Permit Application Review Report
Date: 3/5/2025

Project Name: Markquart RV Ham Lake

Project PAN: P-24-061

Project Purpose: parking lot reconstruction and expansion with associated stormwater treatment features.

Figure 2: Site Plan

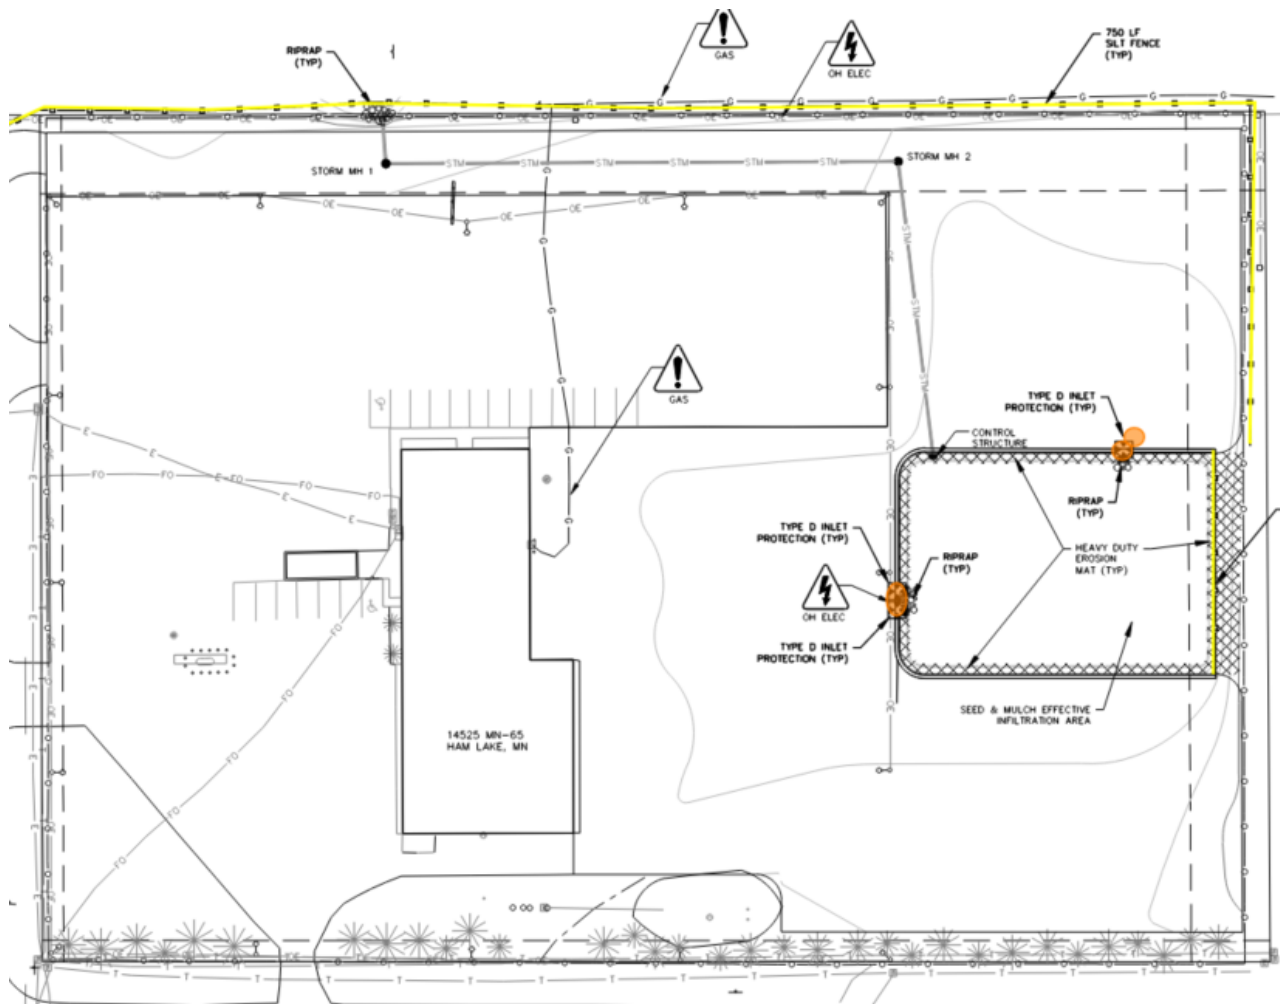
The volume control standard has not been met as shown in Table 2. The proposed design is treating 5,760 sf of existing impervious to make up for some of the 11,495 sf of untreated new/reconstructed impervious. The requirement is not met in full (there is still 5,735 sf of untreated impervious even with the in-kind treatment). However, applicant has illustrated that it is not feasible to treat any more impervious due to existing grade constraints. Due to these constraints the volume control standard has been met to the maximum extent practicable.

Water Quality: The applicant is proposing to treat 5,760 sf of existing impervious surface to make up for some of the 11,495 sf of untreated impervious. The in-kind area may not exceed 15% of the proposed new and reconstructed area. TSS has been reduced to the maximum extent practicable for the untreated impervious surface. The total Water Quality Volume has been provided in aggregate.

Stormwater treatment on site must remove at least 80% of the average annual post development TSS per discharge location. The project achieves 82% TSS removal for the areas directed to the infiltration basin and 0% TSS removal for portion of the new/reconstructed impervious that is not directed to the basin (area 4S). The applicant has illustrated that it is not feasible to treat this area due to existing grade constraints. The TSS removal standard is met to the maximum extent practicable at each discharge point as described.
